July 8, 2021

**SUBJECT- NORTHAMPTON** - Improvements on I-91 Interchange 19 at Rte. 9 & Damon Road  
Project File No. 604597

Figure 1 - Roundabout Lighting

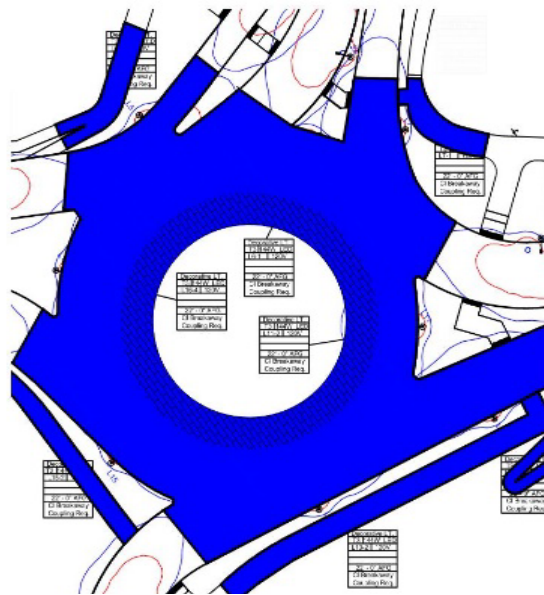
It appears that there may be some confusion in developing the calculation; specifically, regarding which lights are being included in the calculations, as well as what hardscape areas are being lit. Please see Figure 1 below:

In the figure, the blue area represents the extent of lighting provided by the 8 light fixtures that are called out in the figure. The total lumens produced by these 8 fixtures is  $8 \times 13,199 = 105,592$  lumens. Measuring from CADD, the blue area is 37,553 SF. This results in 2.81 Lumens per SF.
